# HUDSON RIVER NATURAL RESOURCE DAMAGE ASSESSMENT (NRDA)

Pre-CAG Meeting, Ft. Edward, NY

June 30, 2011

**Presentations:** *analyses and recommendations to GE on improvements to the Phase 2 Remedial Design that could be implemented to reduce ongoing and remedial injury to natural resources and accelerate recovery of the river.*

# Comparison of Average Tri+ PCBs by River Section from Remedial Design with Model Predictions for 2003 Surface (top 5 cm)

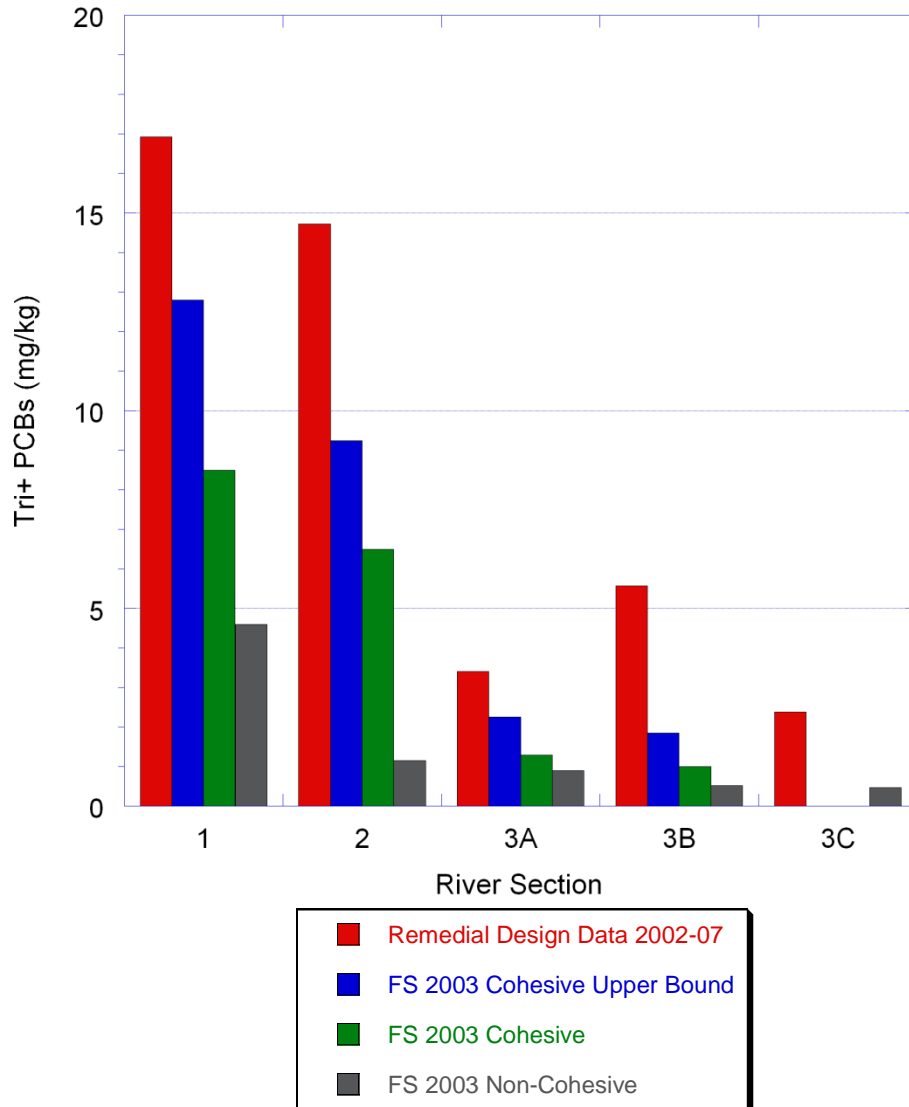
- ❑ Natural recovery models greatly overestimated the rate of recovery.
- ❑ Remedial Design Tri+ PCB concentrations from the top 5 cm (red bars) exceeded the upper bound of model predictions (blue bars) and were more than 2X the concentration predicted for cohesive sediments in all 3 river sections (green bars).
- ❑ Widespread burial of PCBs in the surface sediment was not observed.

# Estimated Post-Dredging Surface Concentrations Compared to Remedy Expectations

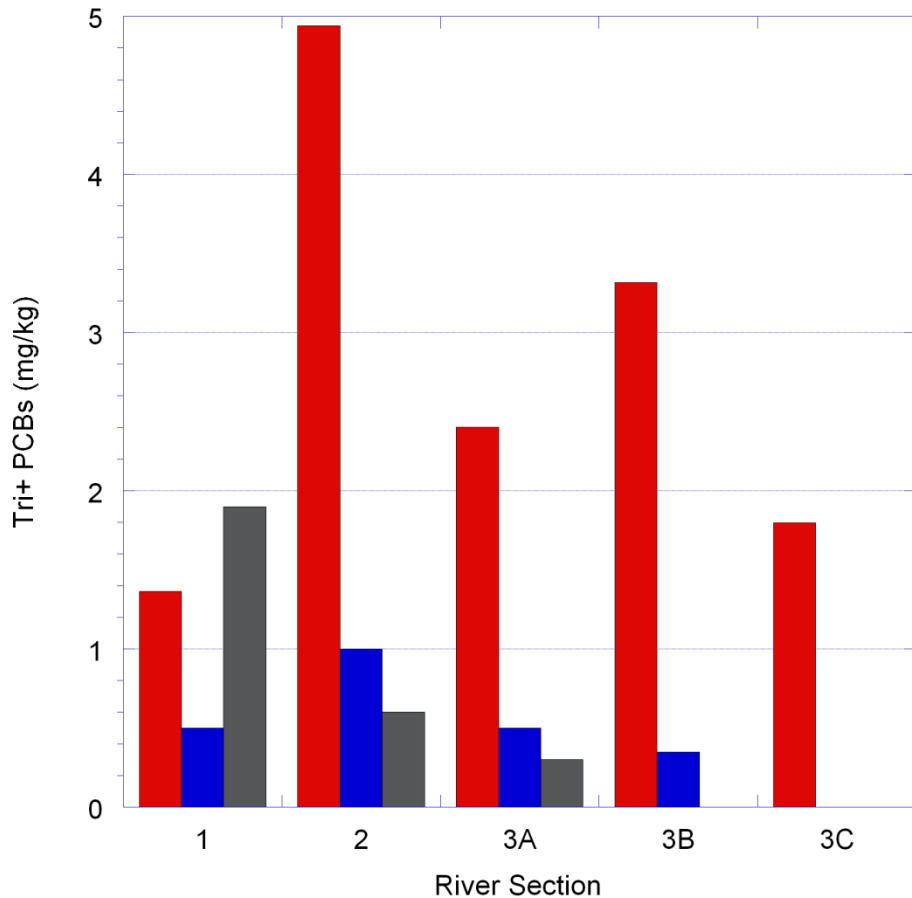
- ❑ River Section 1:  
Estimated post-dredging Tri+ PCB concentrations from Remedial Design data for the top 5 cm (red bars) are comparable to model predictions
- ❑ River Sections 2 and 3:  
Post-dredging concentrations are estimated to be about 5X higher than model predictions

# Estimated Post-Dredging Surface PCBs

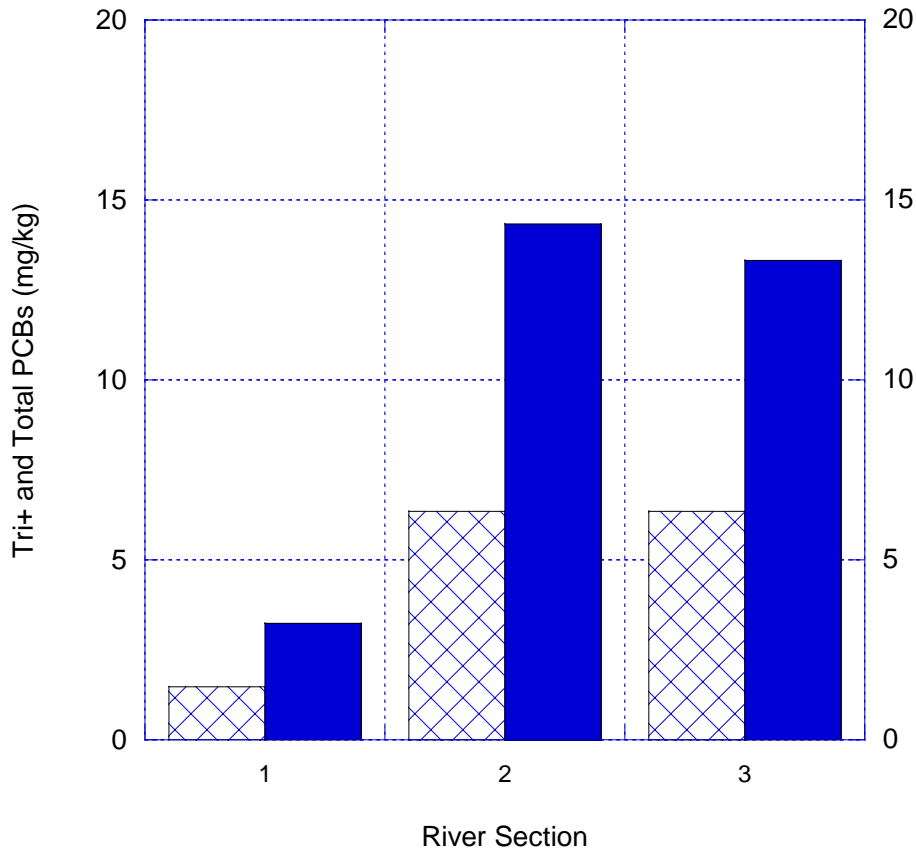
- Surface PCB concentration in River Section 1 will be greatly reduced.
- Surface PCB concentration in River Sections 2 and 3, though reduced, will remain highly elevated

**General Schematic of Cap**

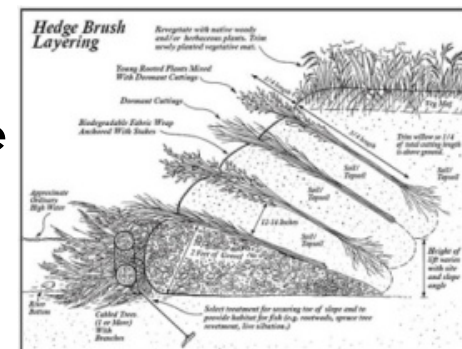
1. Greater PCB removal in the Upper Hudson River
2. More than 1:1 replacement and reconstruction of SAV, RFW, and SHO habitat
3. Provision of sufficient backfill quantity and quality for optimal re-establishment of all disturbed SAV beds
4. Backfill tolerances should be more suitable for habitat reconstruction (RFW:  $\pm 0.1$  ft, SAV: -0.25 ft to +1 ft)
5. More gradual river bottom slopes ( $\leq 10:1$ ) for re-establishment of SAV, RFW, sediment stability, low resuspension of sediments
6. Habitat layer on top of all caps to support emergent and aquatic plants, nesting fish, burrowing invertebrates and wildlife
